**HONDA**  
**AMERICAN HONDA MOTOR CO., INC.**  
1919 Torrance Boulevard • Torrance, CA 90501-2746  
(310) 783-2000

On November 21, 2000, Honda Motor Co., Ltd. (HMC) determined that a safety-related problem exists due to potential for a clutch failure in all 2000 model year and certain 2001 year Honda CBR929RR motorcycles. The following information is submitted pursuant to the requirements of 49 CFR 573.5.

2000-2001 Honda CBR929RR Clutch Recall

## CLUTCH LIFT LEVER ILLUSTRATIONS

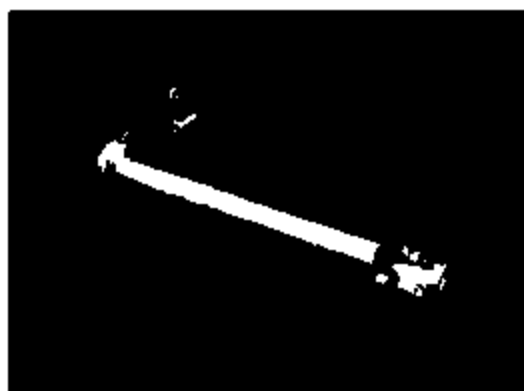
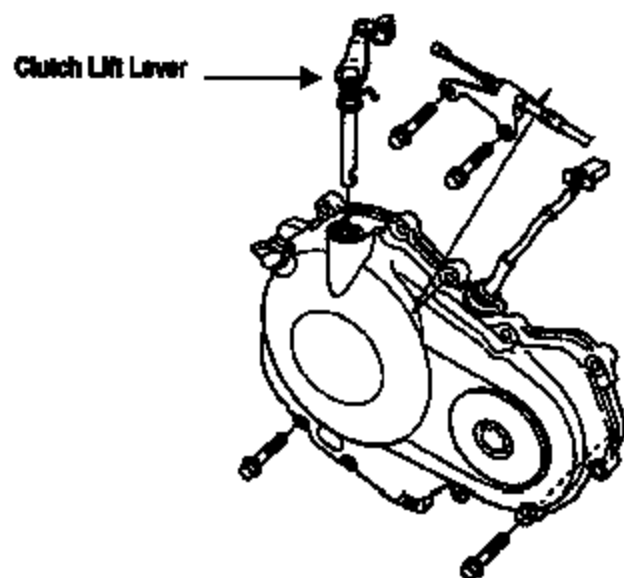
The affected motorcycles were also equipped with a newly designed clutch lift lever. Preceding models were equipped with a lifter lever of a different design. Vehicles manufactured after the affected vehicles will be equipped with a redesigned lifter lever.

Additionally, the clutch lift lever shaft does not have sufficient strength and may fail when the clutch is applied. (See attached drawing.) Stress concentration at the machined end of the shaft can cause the shaft to crack or break. As a result, the rider would not be able to disengage the clutch.

The owners of all affected vehicles will be notified by mail and asked to take their motorcycle to an authorized Honda dealer. The dealer will install a clutch kit that includes a redesigned clutch outer, judder spring and other parts intended to reduce stress on the clutch, free of charge. The dealers will also be instructed to install a new, redesigned clutch lifter lever.
